## ADDENDUM 2

### **Materials Recovery Facility Retrofit**

# CD Package for Materials Recovery Facility Equipment Retrofit

2411  
10/08/2024 - CD  
SHEET NAME  
ELECTRICAL POWER RISER  
DIAGRAM & SCHEDULES  
(2 OF 2)  
SHEET NUMBER  
E0.04

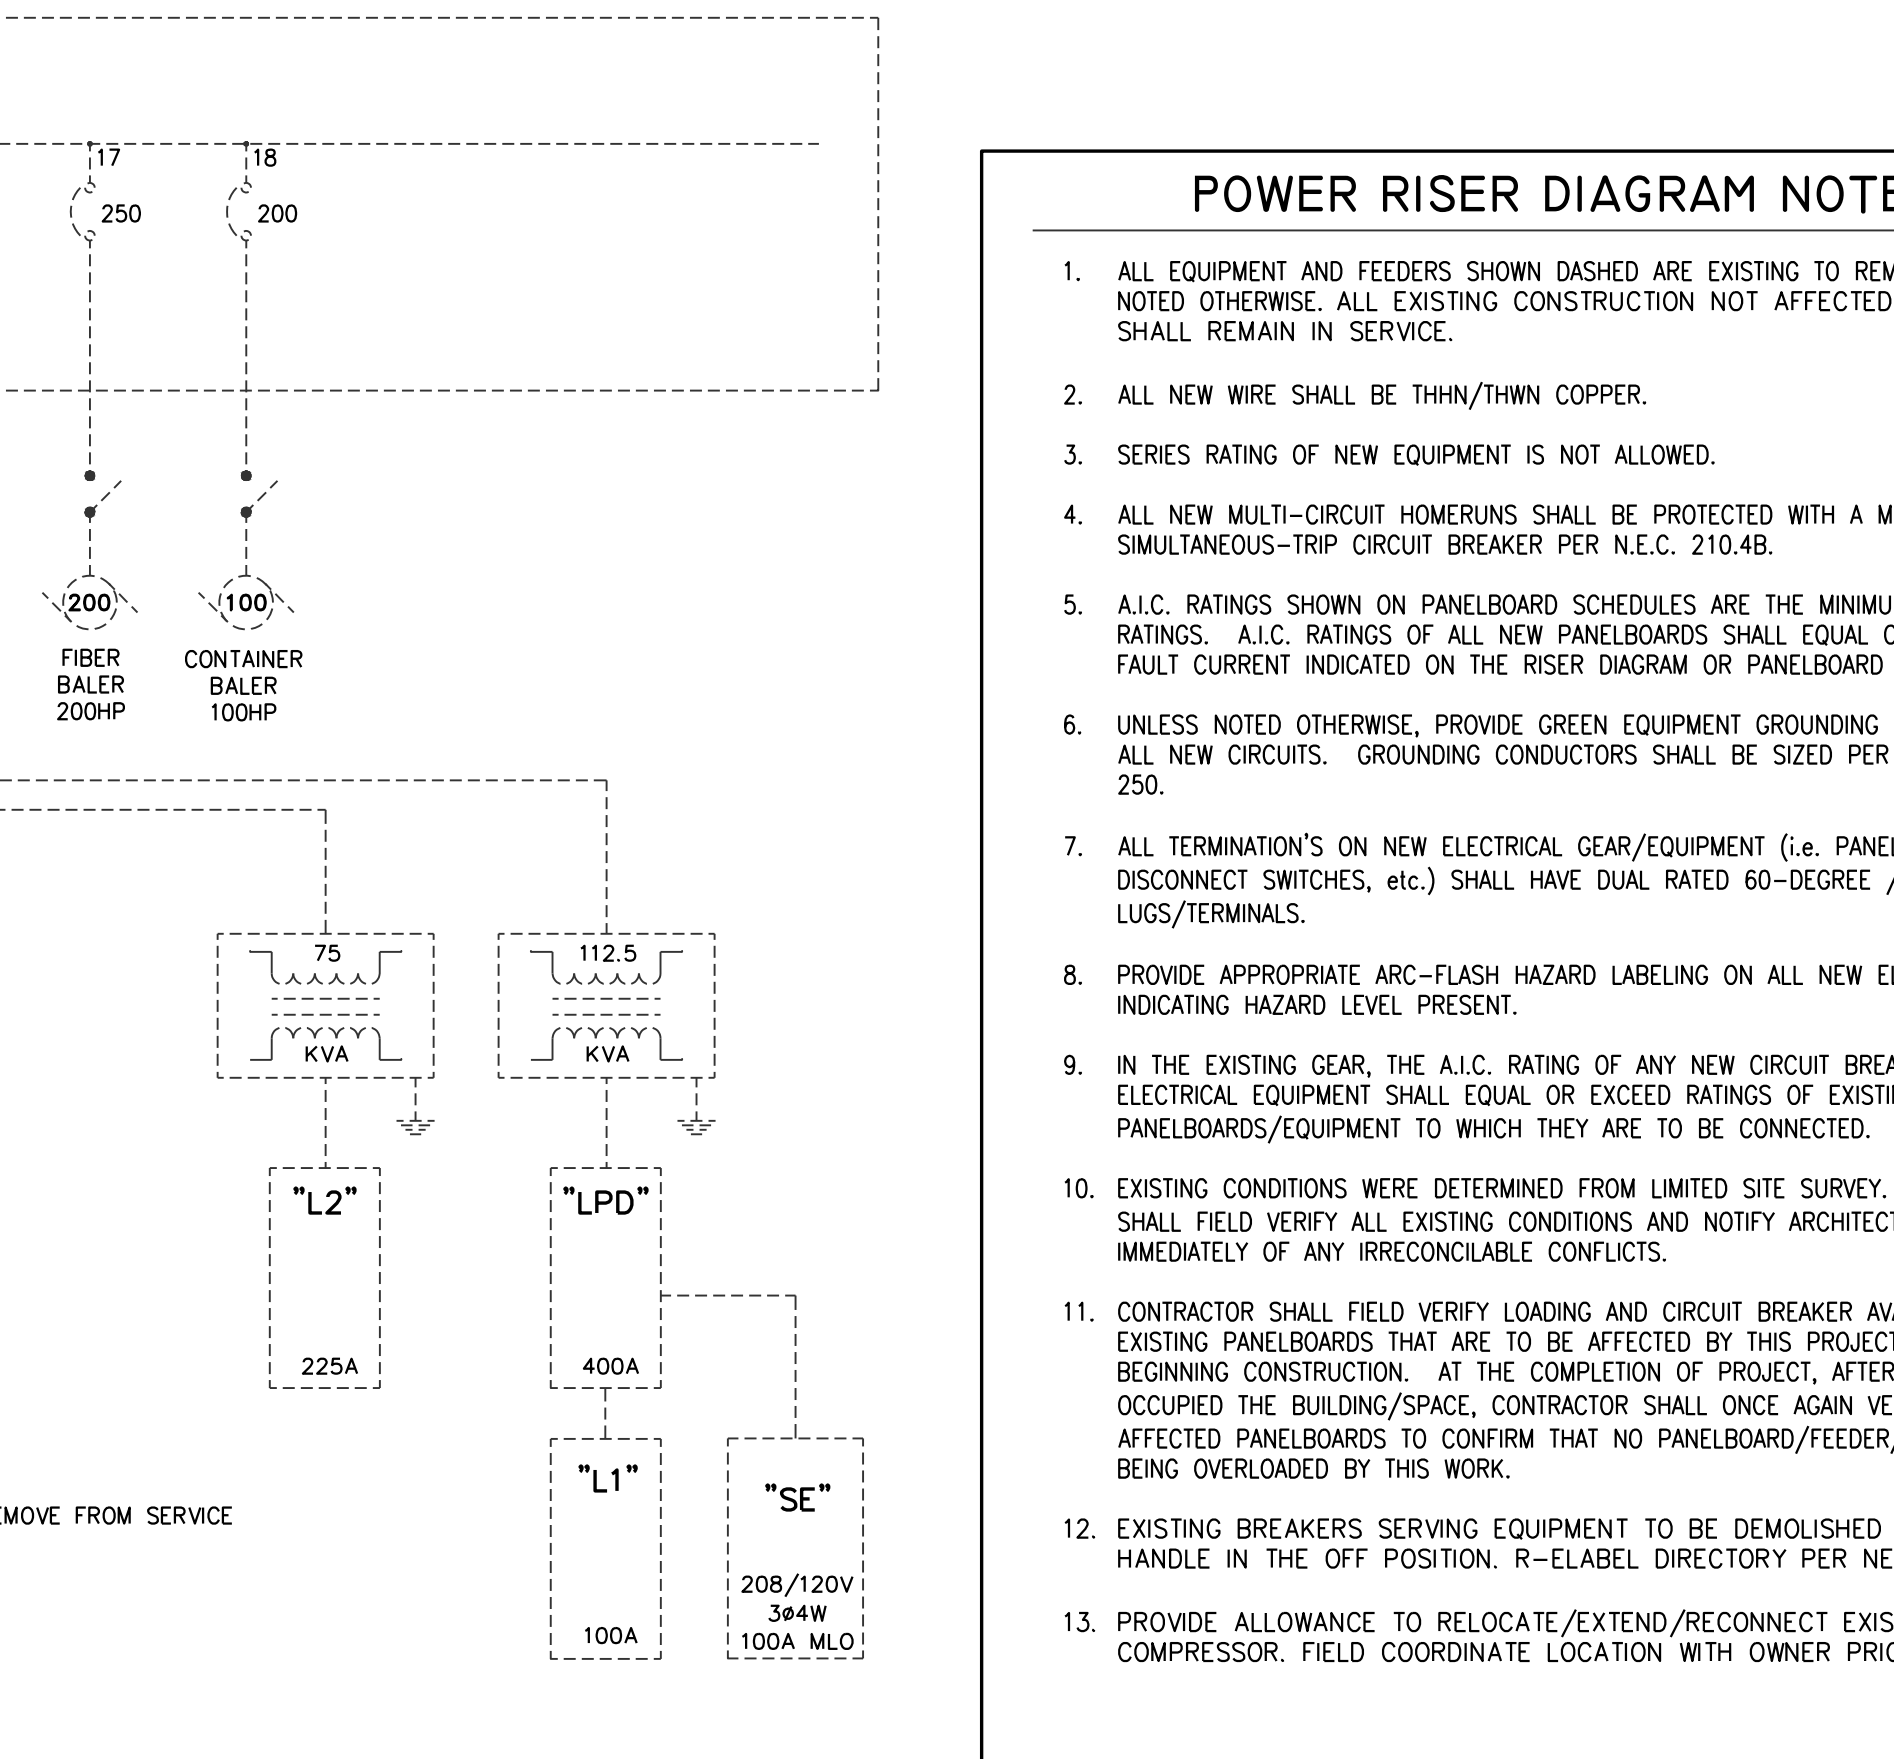
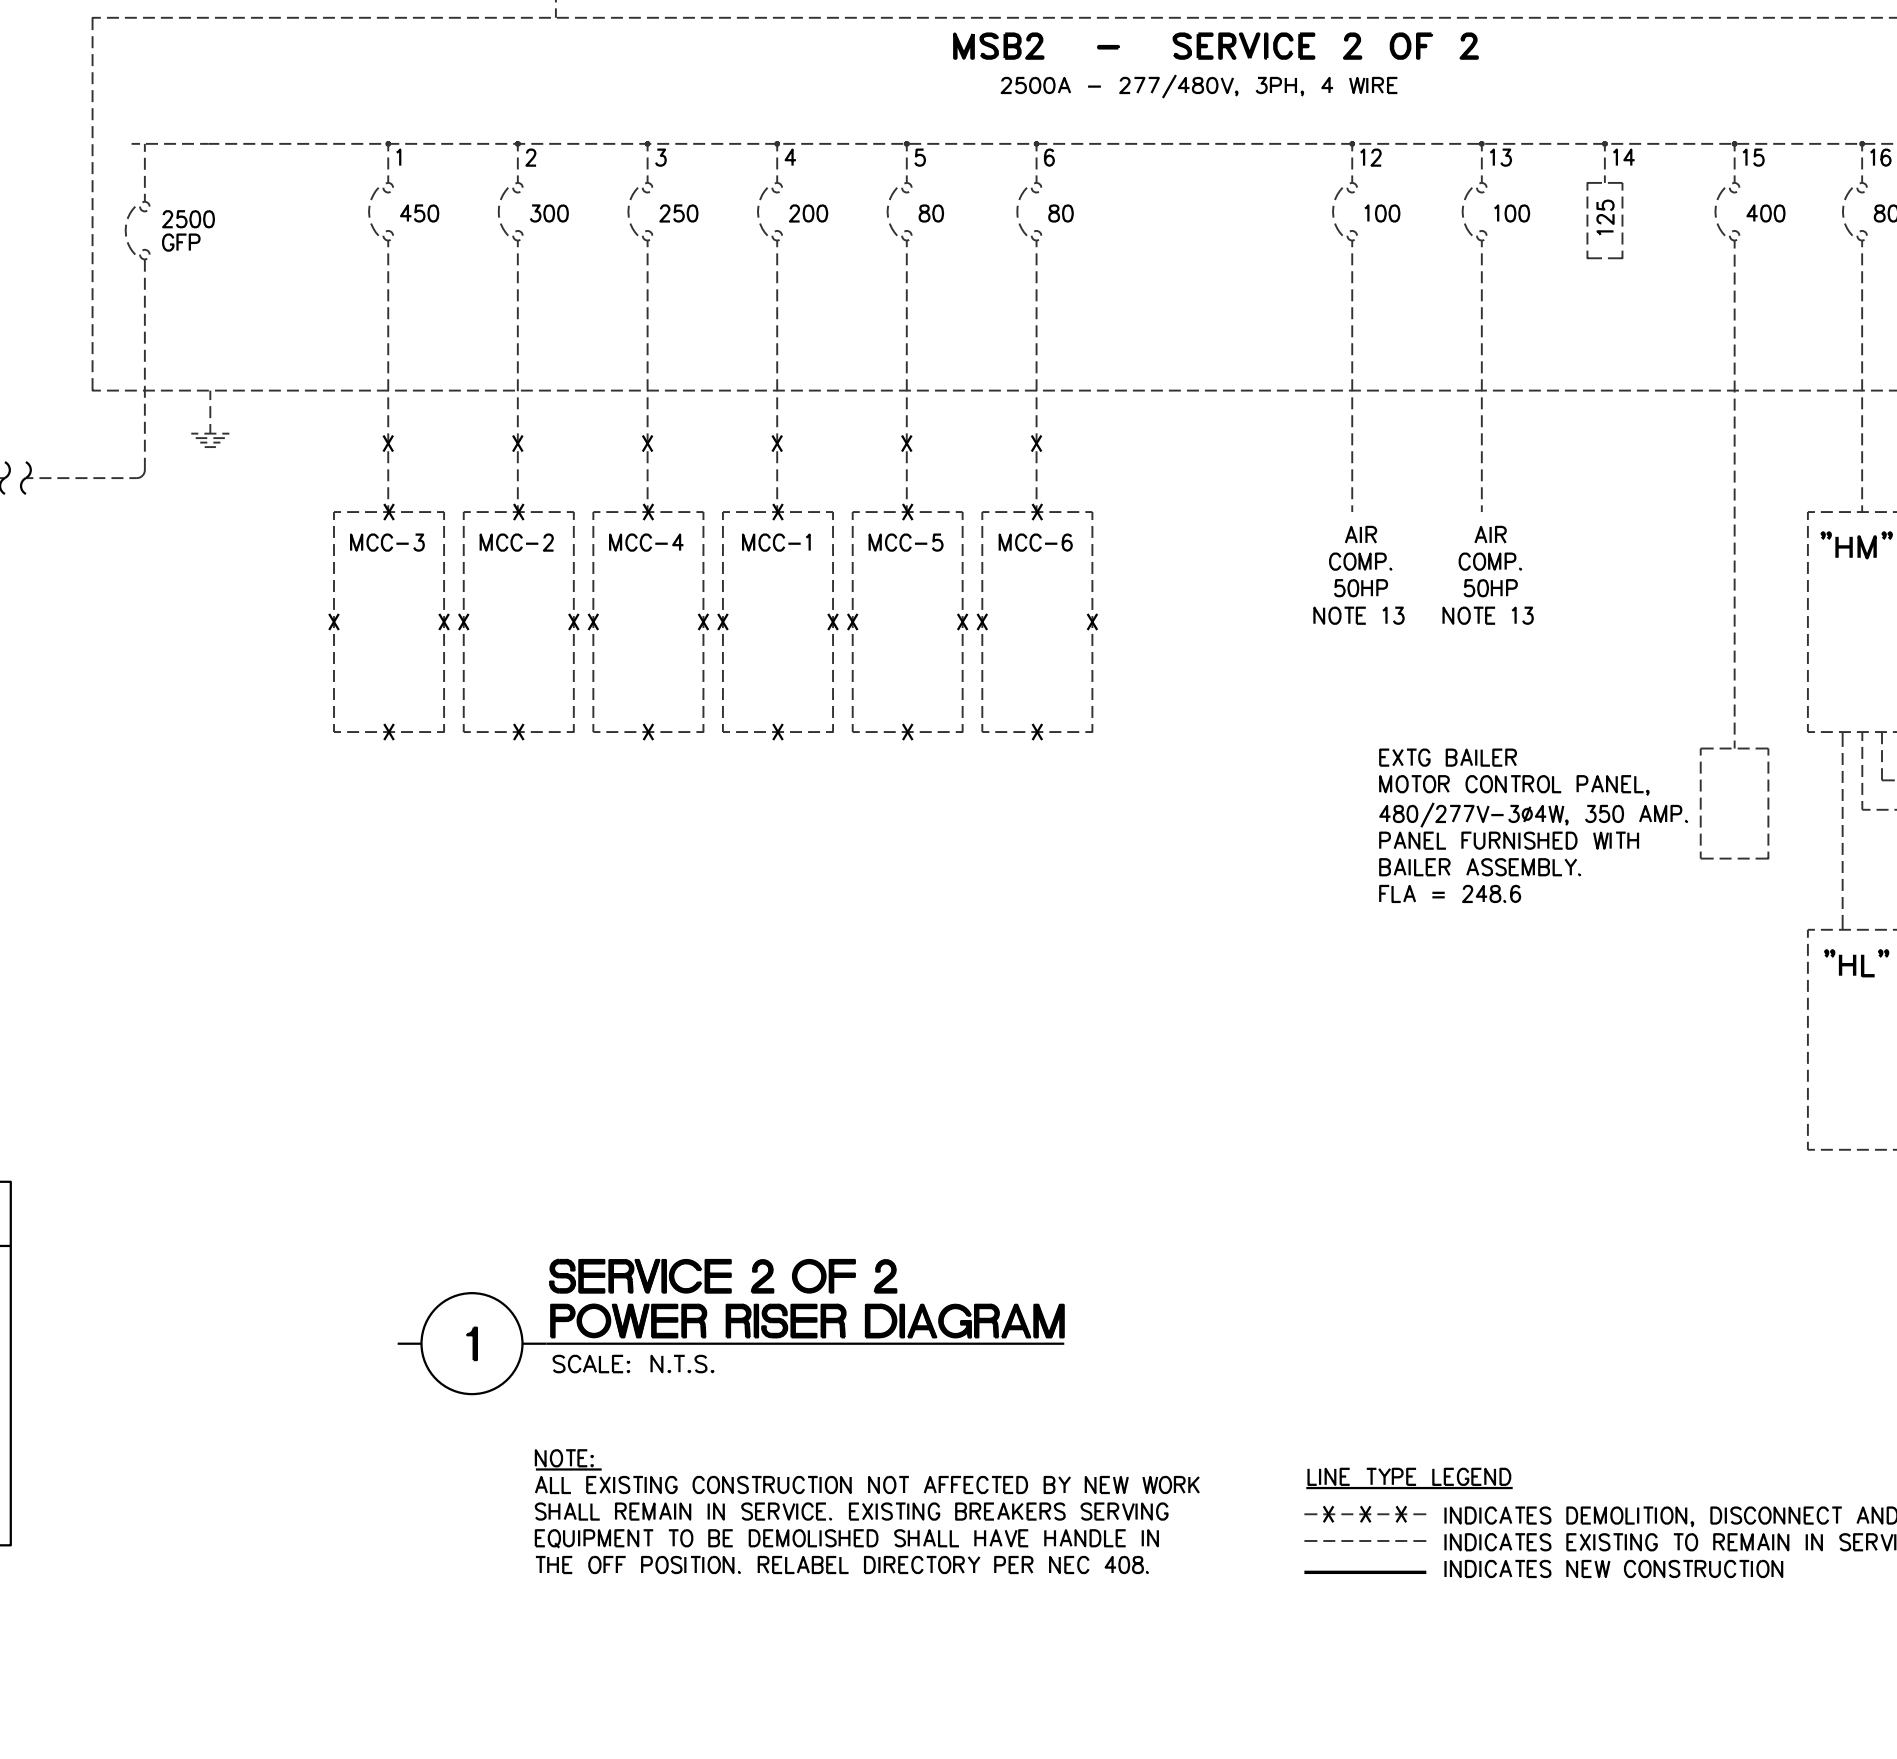
G0.00	Corrected index of Mechanical, Fire Sprinkler & Electrical sheets
G0.01	Corrected date of Addendum 01
M0.01	Added note for schedule/sequencing clarification.
M1.01	Clarification to note about RTU demolition scope.
FS0.01	Dry riser detail and fire hose reel specification added.
FS1.03	Clarification of extent of tipping floor area
FS1.04	Clarification of extent of tipping floor area and fire hose reel locations added.
FS3.04	Fire hose reel piping locations added.
E0.04	CCTV power circuit added
E1.01	Power to added CCTV cameras

SHEET NUMBER  
**T-100**

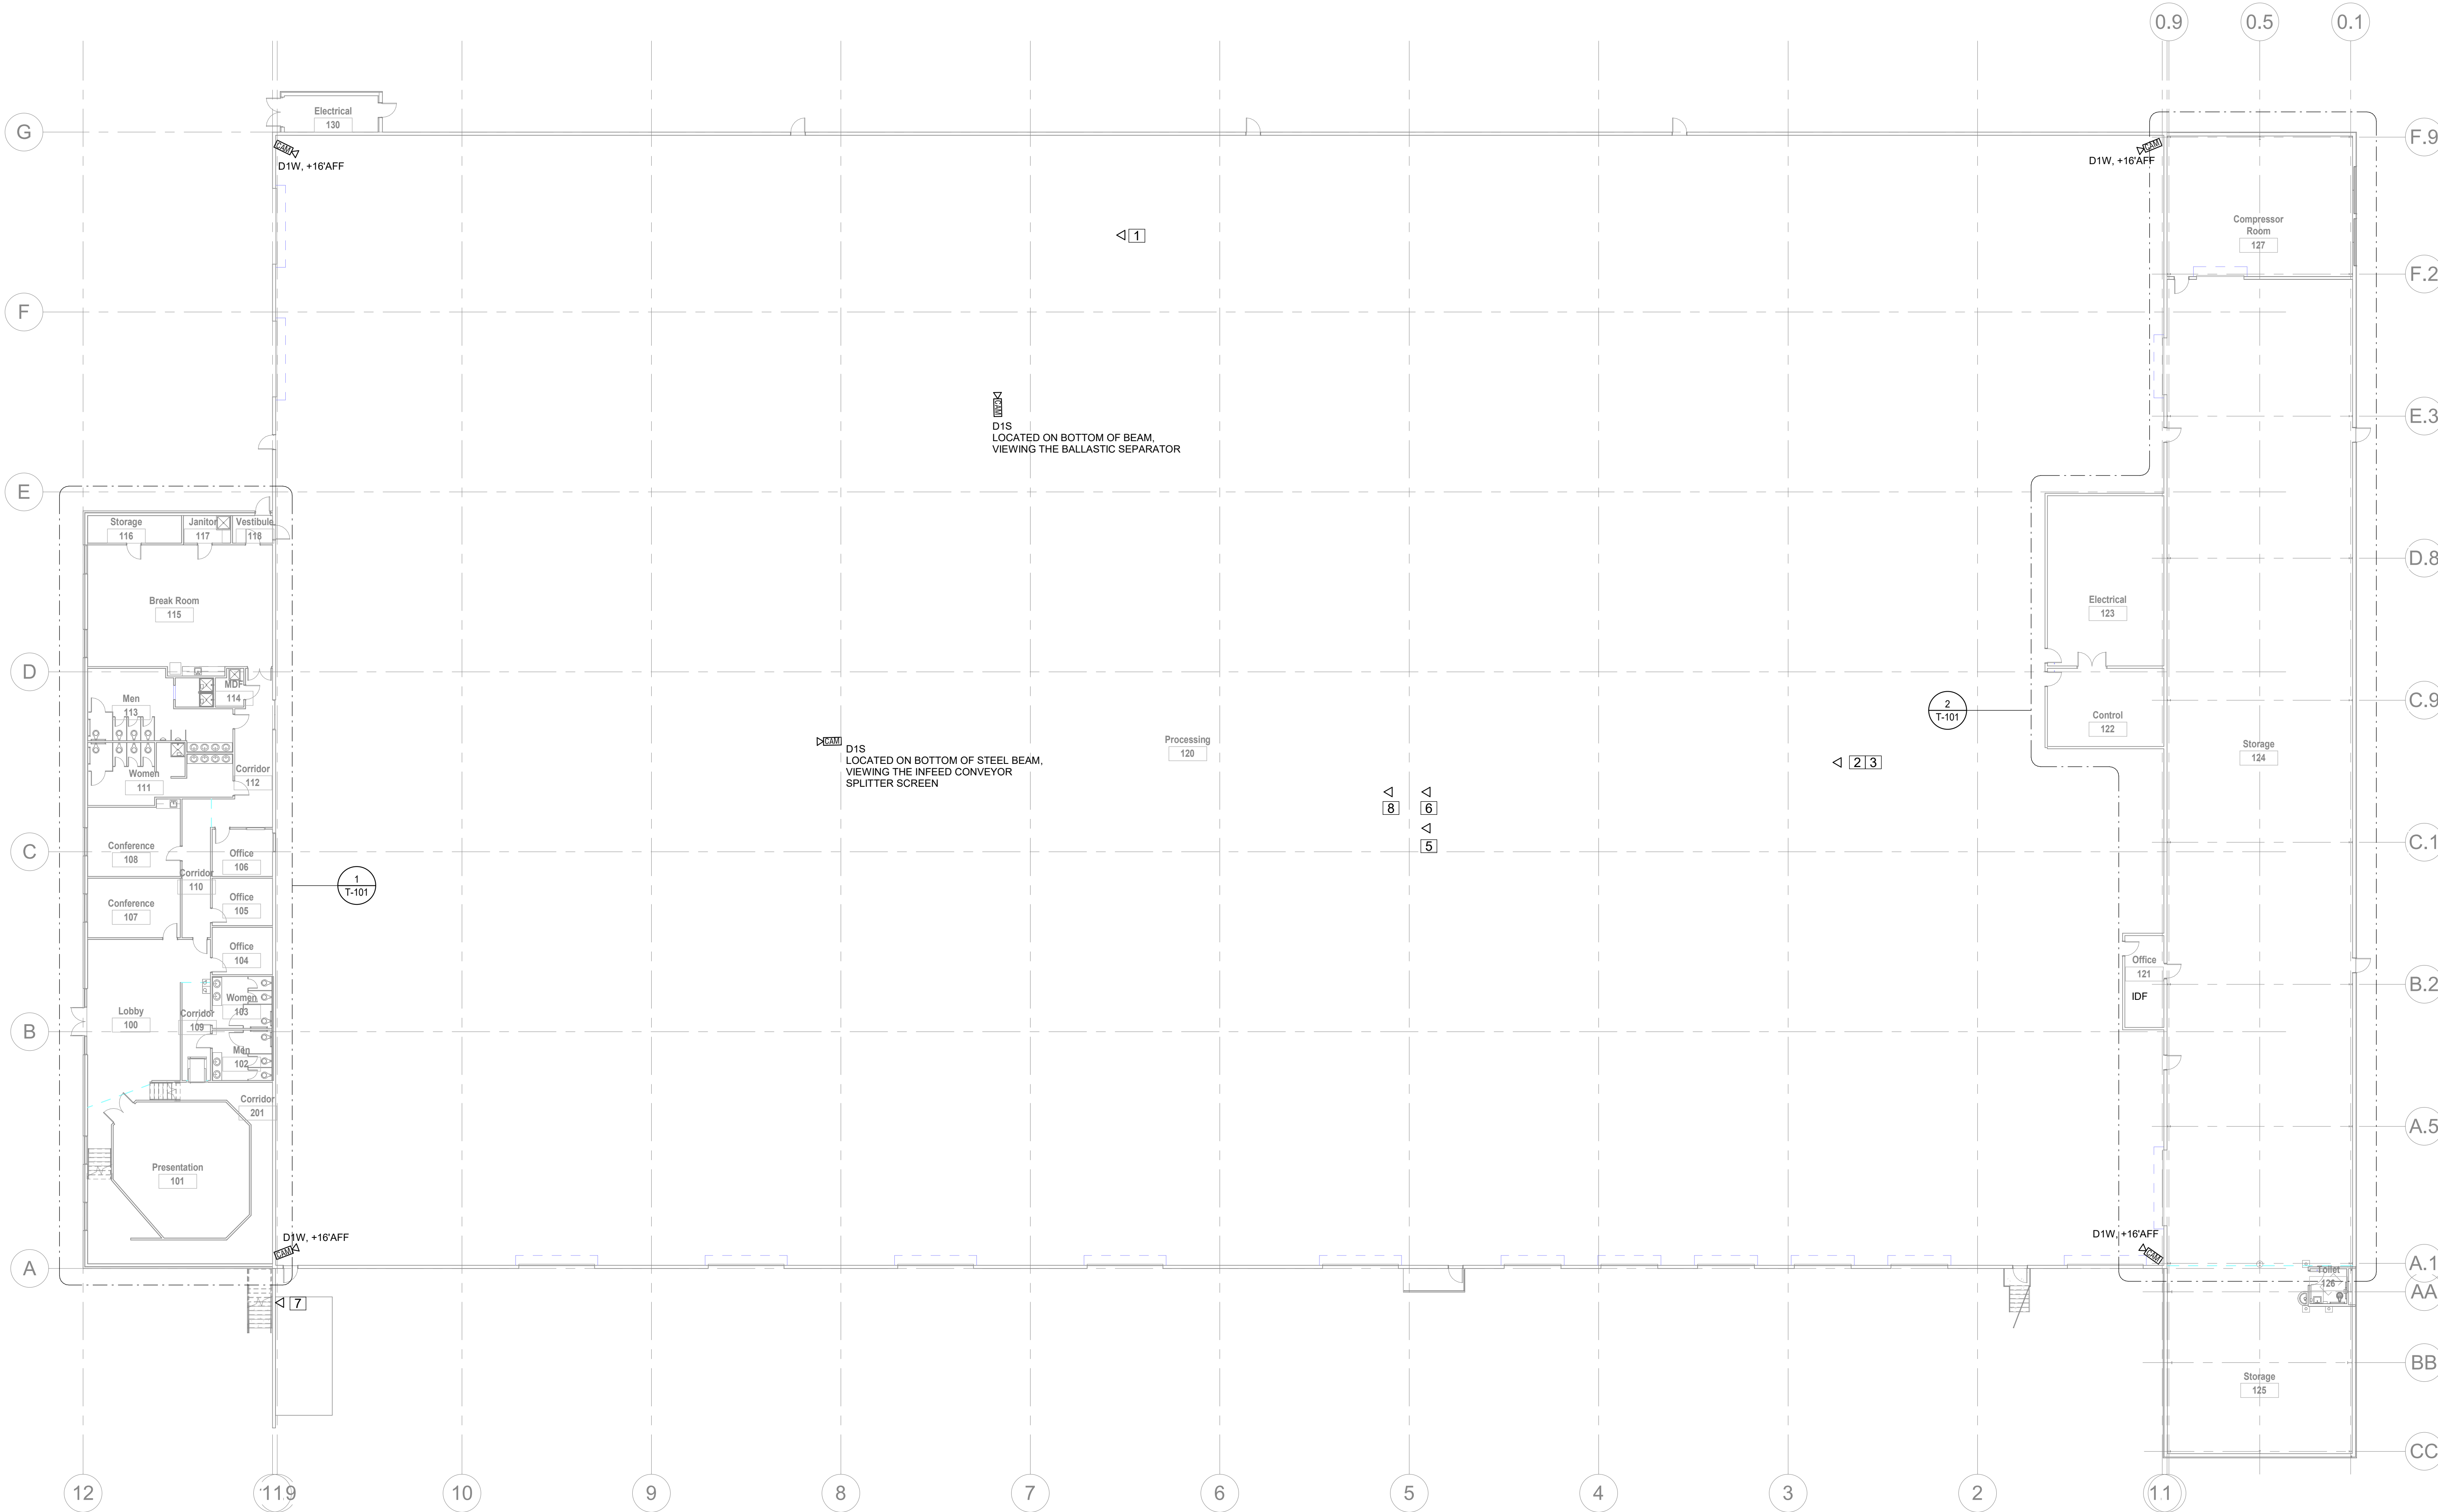
T-001	Symbol legend updated
T-100	Additional security camera locations added
